RUSSIAN MARITIME REGISTER OF SHIPPING
HEAD OFFICE

CIRCULAR LETTER

No. 314-44-909c

Re:
amendments to the Rules for the Classification and Construction of Sea-Going Ships, 2016, ND No. 2-020201-087-E, in connection with coming into force of the provisions of IACS Unified Requirements (UR) S21A (May 2011) (Corr.1 Oct 2011) (Rev.1 May 2015)

Fig 7.10.6.11 Forces due to container loads";

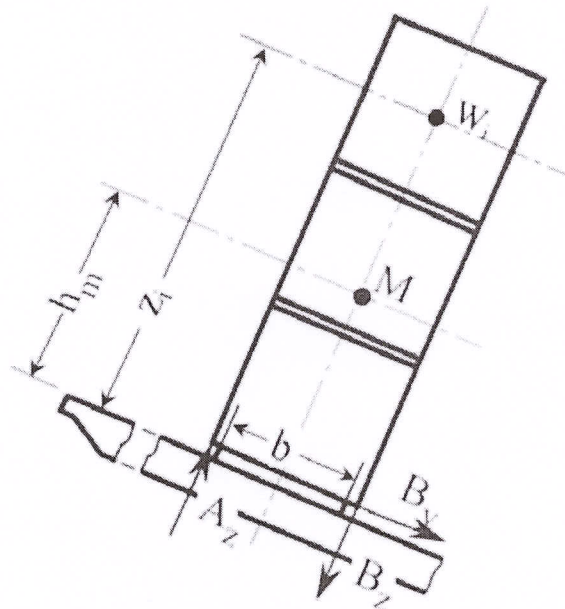
7.10.6.11.2 The loads, in kN, applied at each corner of a container stack, and resulting from heave, pitch, and the ship's rolling motion (i.e. ship in heel condition) shall be determined as follows, (refer also to Fig. 7.10.6.11): "

b = distance between midpoints of foot points in m (refer to Fig. 7.10.6.11);", the rest remaining as it stands";

"N o t e. When strength of the hatch cover structure is assessed by grillage analysis according to 7.10.6.21, h_m and z_i need to be taken above the hatch cover supports (refer to Fig.7.10.6.11). Forces B_y does not need to be considered in this case.

Table 7.10.6.12

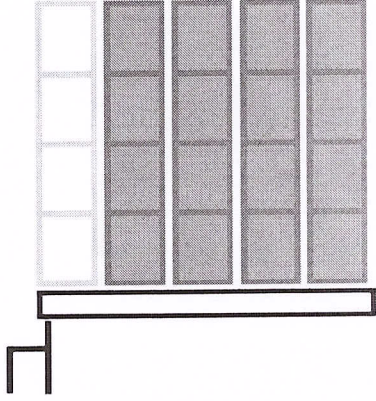
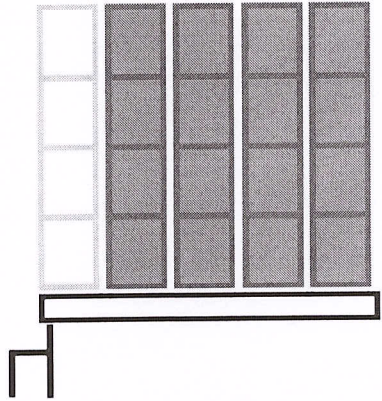
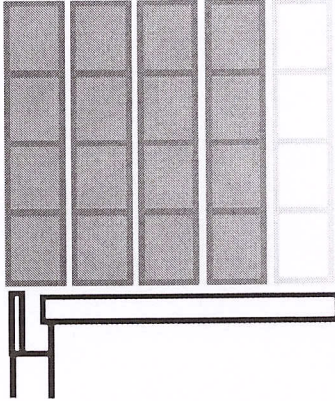
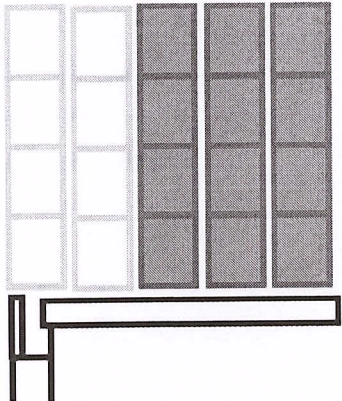
"**7.10.6.12** The load cases defined in 7.10.6.11.1 and 7.10.6.11.2 shall also be considered for partial non homogeneous loading which may occur in practice, e.g. where specified container stack places are empty. For each hatch cover, the heel directions, as shown in Table 7.10.6.12, shall be considered.

The load case partial loading of container hatch covers can be evaluated using a simplified approach, where the hatch cover is loaded without the outermost stacks that are located completely on the hatch cover. If there are additional stacks that are supported partially by the hatch cover and partially by container stanchions then the loads from these stacks are also to be neglected (refer to Table 7.10.6.12.).

In addition, the case where only the stack places supported partially by the hatch cover and partially by container stanchions are left empty is to be assessed in order to consider the maximum loads in the vertical hatch cover supports.

Fig.7.10.6.16";

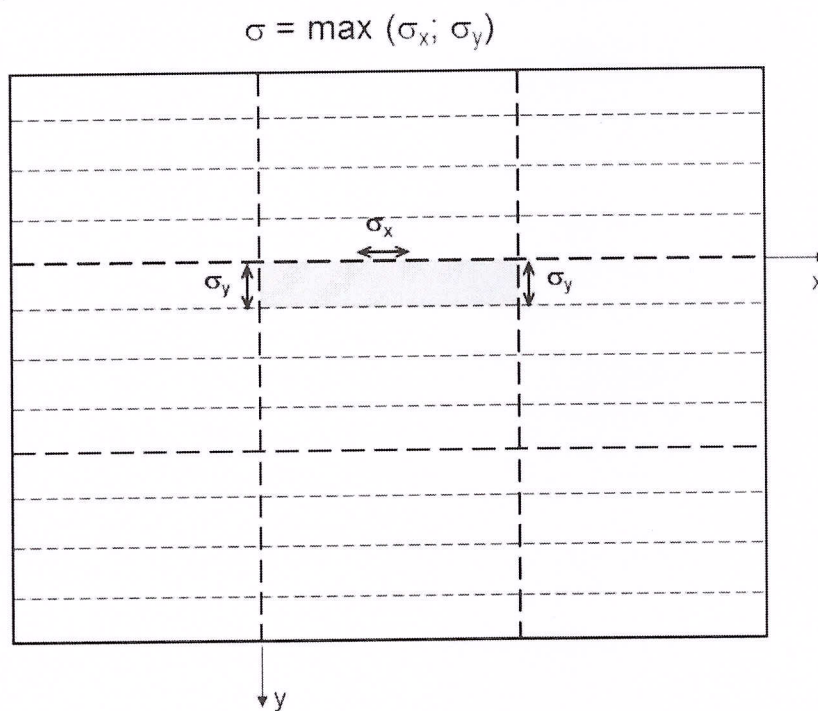
" σ - maximum normal stress, in N/mm^2 , of hatch cover top plating, determined according to Fig. 7.10.6.16";

Fig. 7.10.6.16 shall be replaced with new Fig. 7.10.6.16 as follows: "

Fig. 7.10.6.39-1

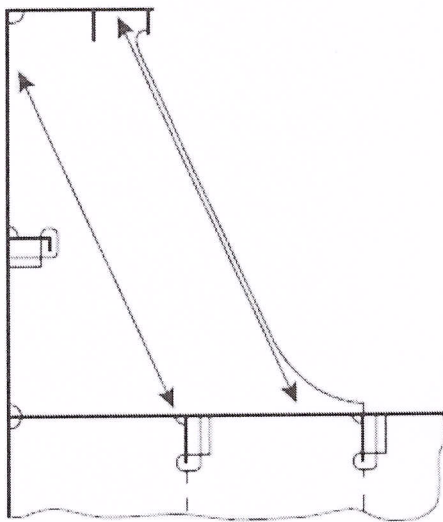
"At the connection with deck, the net section modulus Z , in cm^3 , of the coaming stays designed as beams with flange (refer to Figs. 7.1.6.39-1 and 7.1.6.39-2) shall be taken not less than: ", the rest remaining as it stands;

shall be supplemented with new Figs 7.10.6.39 -1; 7.10.6.39 -2; 7.10.6.39 -3; 7.10.6.39 -4:

Fig. 7.10.6.39-3

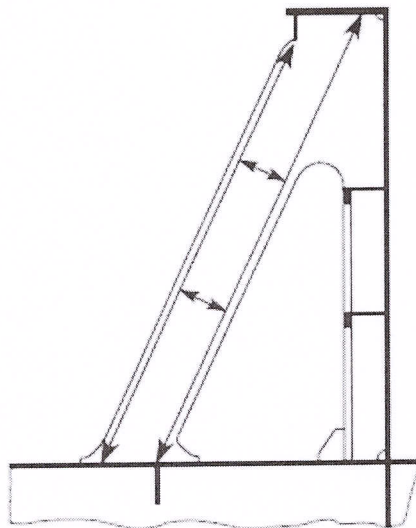
"...For other designs of coaming stays, such as those shown in Figs. 7.10.6.39-3 и 7.10.6.39-4, the stresses shall be determined through a grillage analysis or FEM. The calculated stresses shall comply with the permissible stresses according to 7.10.6.14.";

Fig. 7.10.6.43 shall be amended with new Fig. 7.10.6.43:

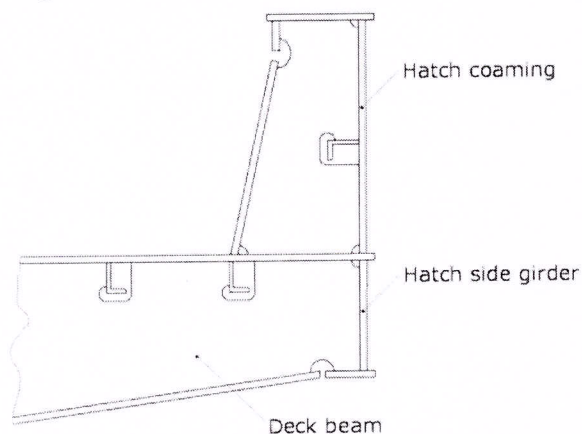
"...Coaming plates shall extend to the lower edge of the deck beams or hatch side girders shall be fitted that extend to the lower edge of the deck beams. Extended coaming plates and hatch side girders shall be flanged or fitted with face bars or half-round bars. Fig. 7.10.6.43 gives an example.";
